DEVELOPMENT CONSENT AUTHORITY
DARWIN DIVISION

AGENDA ITEM: 2 **MEETING DATE:** 09/10/2026 **FILE:** PA2026/0305

APPLICATION PURPOSE:	Dwelling-group (6 x 3 bedroom) in a 2-storey building
SUBJECT SITE:	Lot 2017 (6) Queen Street, Stuart Park, Town of Darwin
ZONE:	Zone MR (Medium Density Residential)
SITE AREA:	1112 m^2
APPLICANT	ThinkDA Planning – Director Amit Magotra
PERSONS ON WHOSE BEHALF THE APPLICATION IS MADE	Rob Watt Designs – Director Rob Watt
LANDOWNER	Apeiron Developments Pty Ltd – Directors Christos Diamandopoulos and Nikolas Mpilias
ANY PERSON WITH AN AGREEMENT TO ACQUIRE AN INTEREST IN THE LAND	None

Figure 5:Compliance with sub-clause 6 requirements

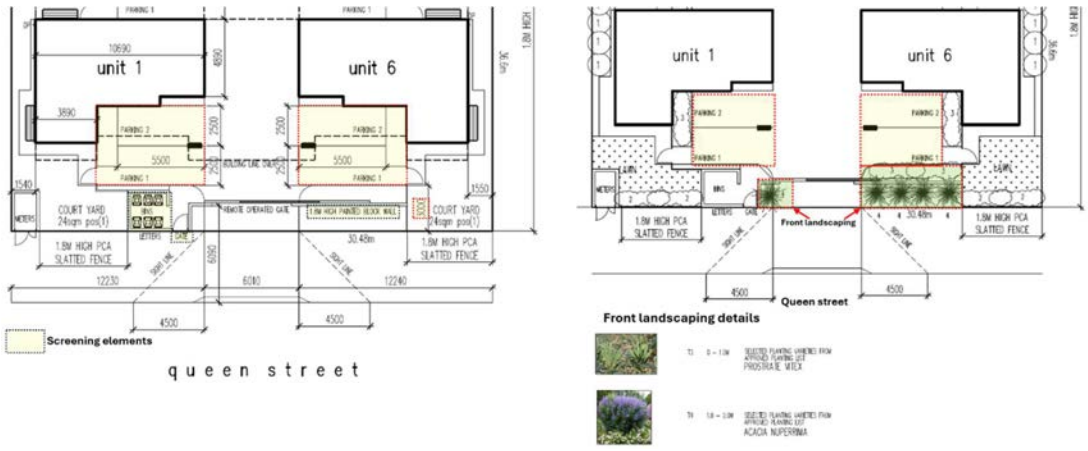
Parking Spaces 1 and 2, associated with Units 1 and 6 respectively, are located at the front of the site and are set back 3 metres from the Queen Street frontage. The parking space serving Unit 6 is largely screened from public view by the proposed 1.8-metre-high masonry block wall. The parking space serving Unit 1 is screened by a combination of slat fencing and a bin storage area (refer to **Figure 5** below). Accordingly, the visual impact of the parking areas on the streetscape is appropriately mitigated.

Figure 6: Extent of the front setback variation and proposed landscaping and fencing treatments

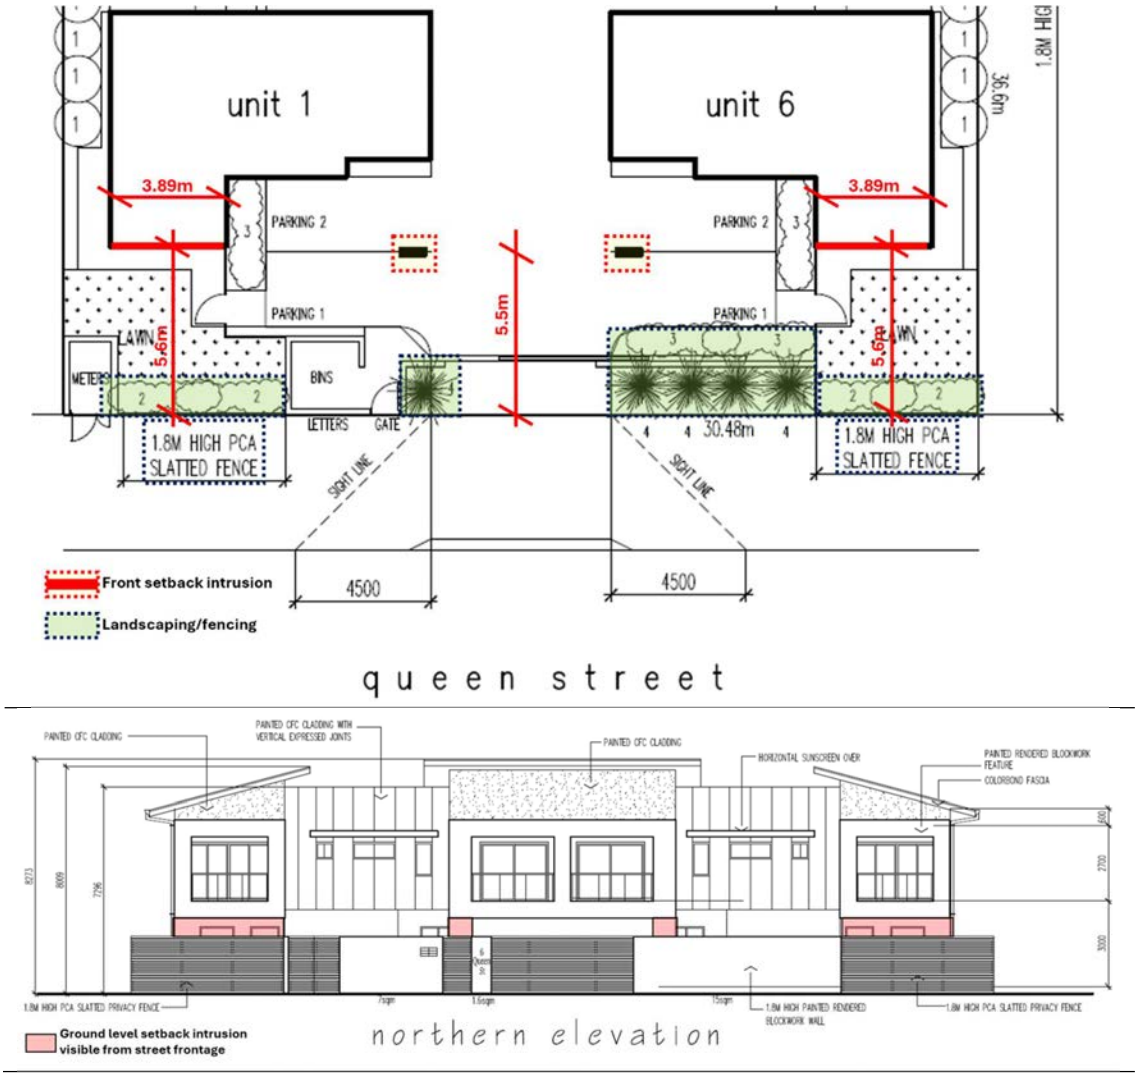
Figure 6, on the following page, illustrates the extent of the front setback variation for Units 1 and 6, including the location of the car parking columns, as well as the proposed landscaping and fencing treatments that provide effective screening and mitigate potential visual bulk and building massing impacts when viewed from the street frontage.

Figure 8: Built form and building articulation of the development as viewed from front and side boundary

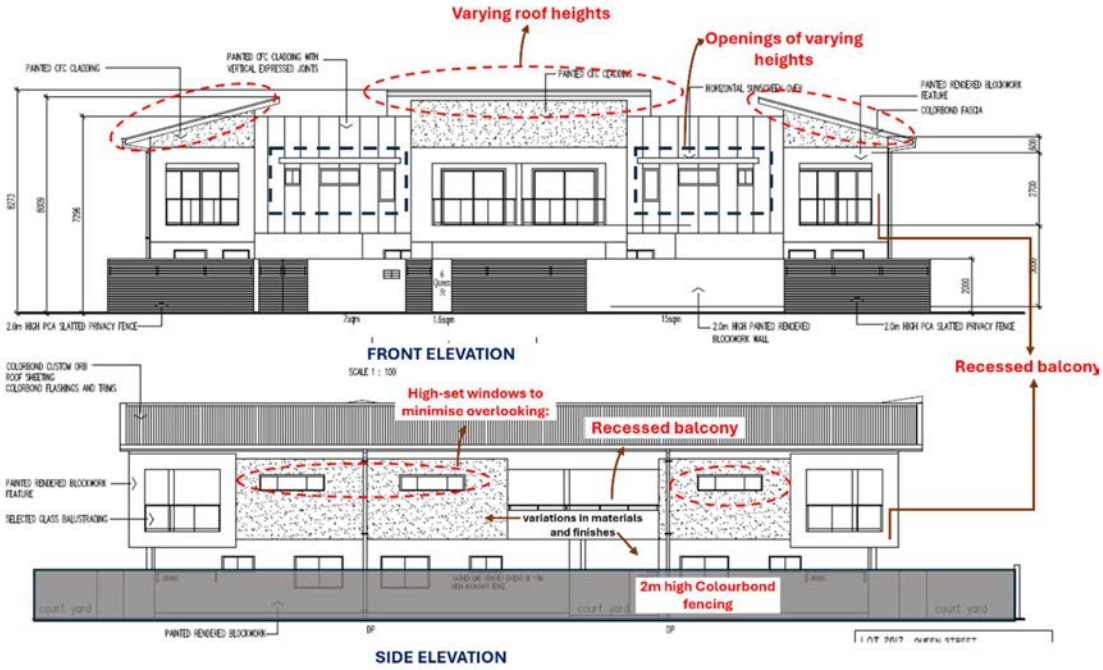
Figure 8 below illustrates the built form and articulation of the development as viewed from the side boundaries.

Figure 10: Building Articulation

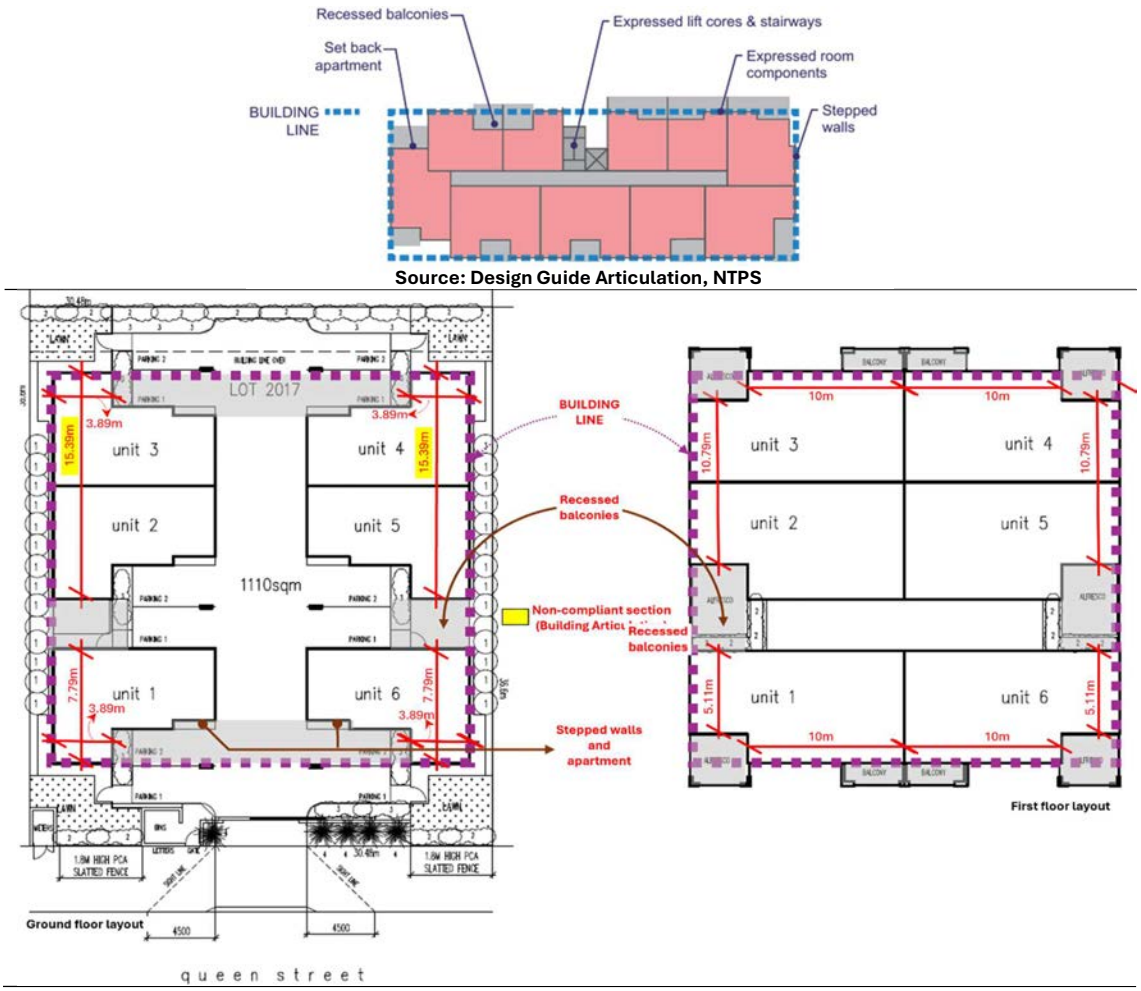
The proposed development is generally compliant with the requirements. However, the ground-level façades of Units 2 and 3 (western elevation) and Units 4 and 5 (eastern elevation) incorporate a continuous building length of 15.39 m without the required 1 m by 1 m step or recess. The extent of the non-compliance is illustrated in **Figure** 10 below.

Figure 11: Front boundary fencing details

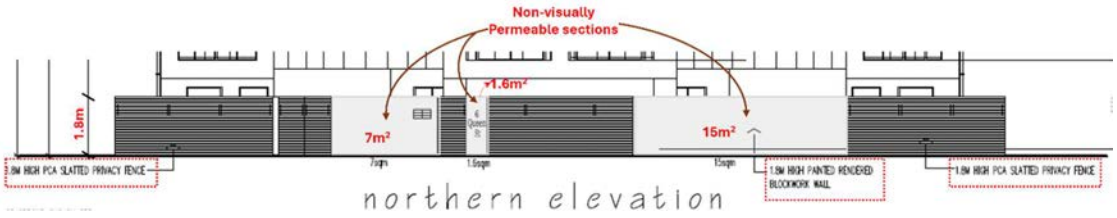
The proposed front fencing comprises a combination of slatted privacy fencing and painted rendered blockwork walls. The rendered blockwork sections, which are considered non-visually permeable, have a combined area of approximately 23.6 m^2 (7.0 m^2 + 1.6 m^2 + 15.0 m^2). Accordingly, the proposed front fencing complies with this requirement. Refer **Figure 11**, below.

Date MAY 2026
Scale AS SHOWN
JOB No. 26042-SK6
Amend.

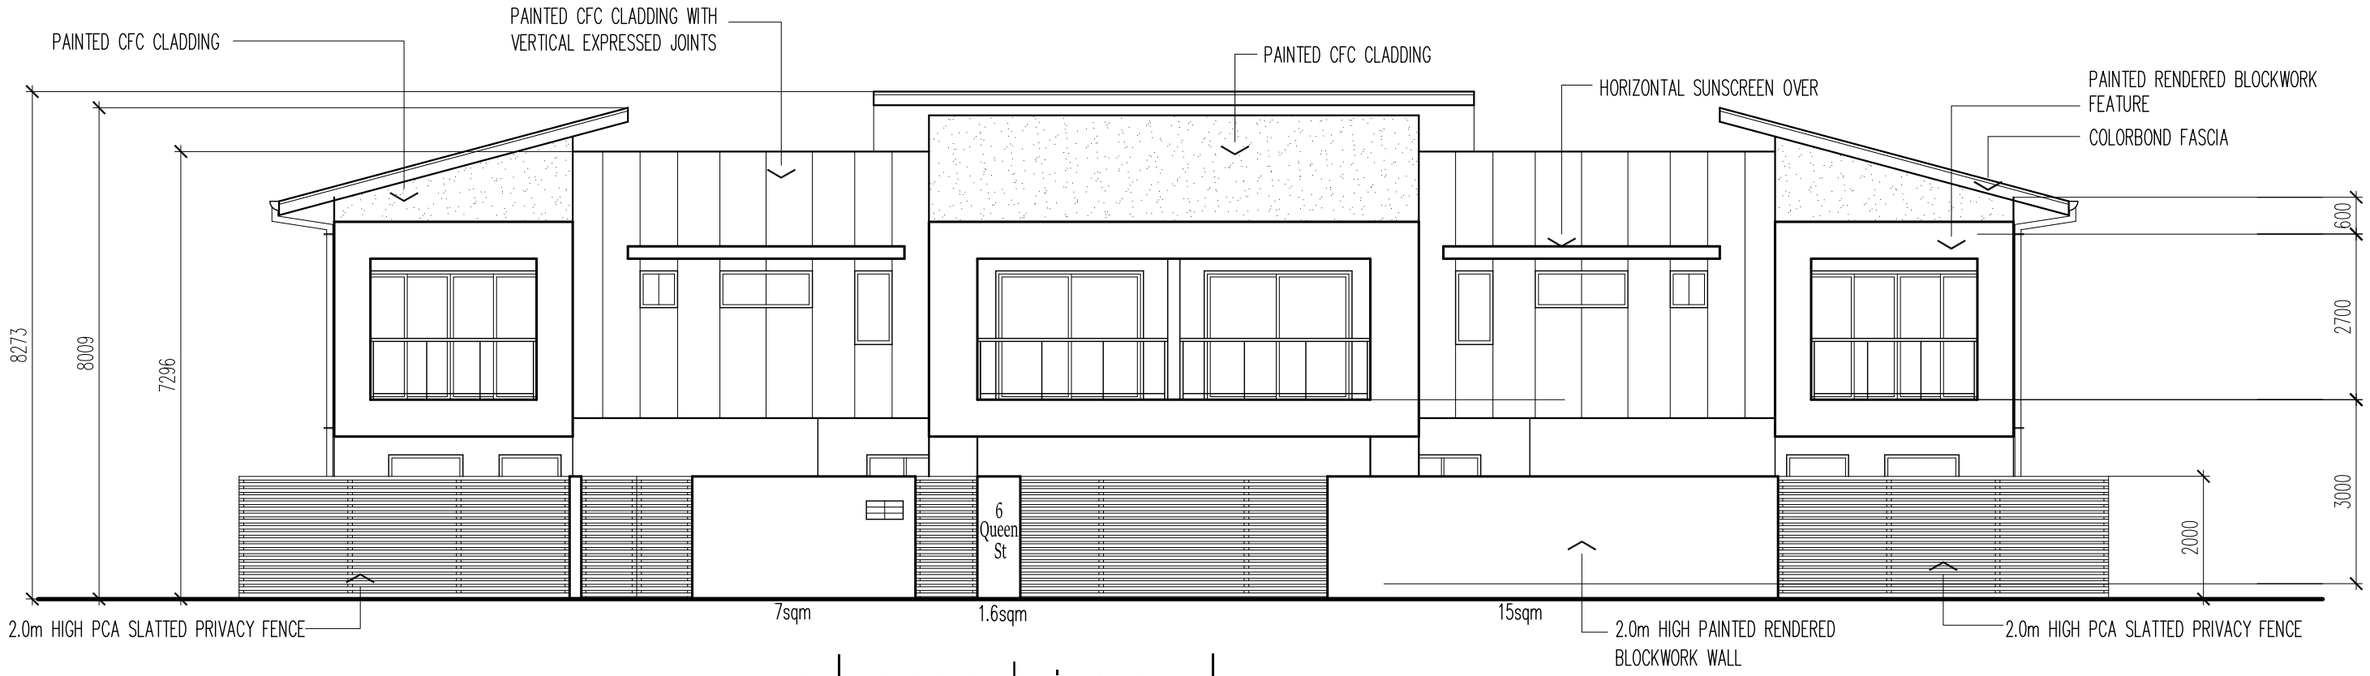
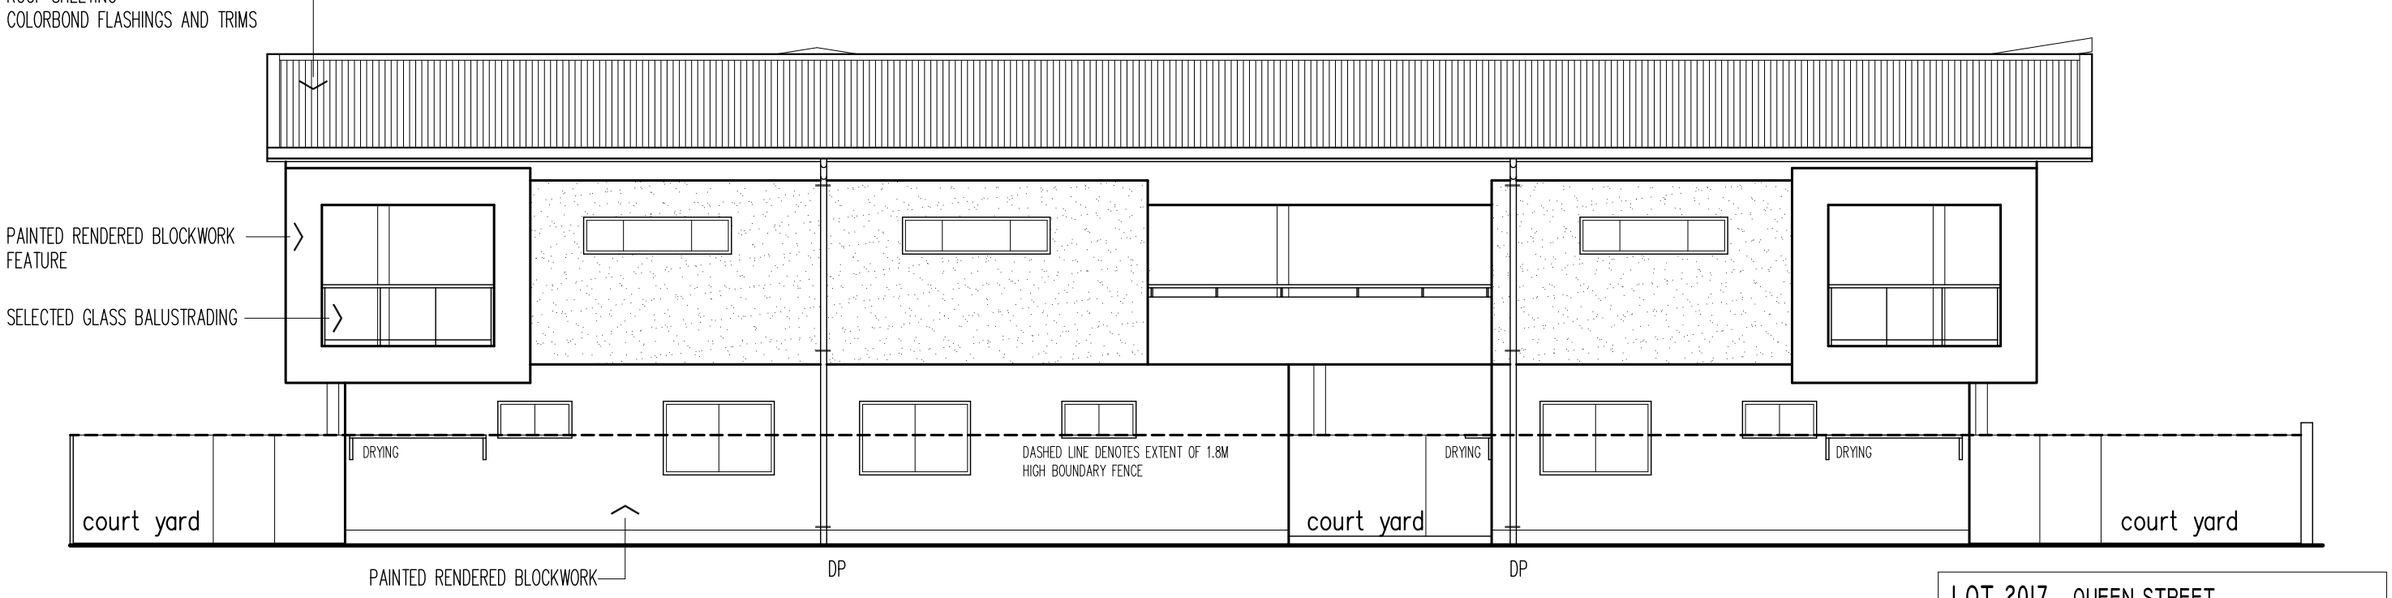
5.	Locate air conditioners where they are accessible for servicing.	**Complies** Elevation (Drawing sheet SK6) shows Ac units placed in easily accessible areas.
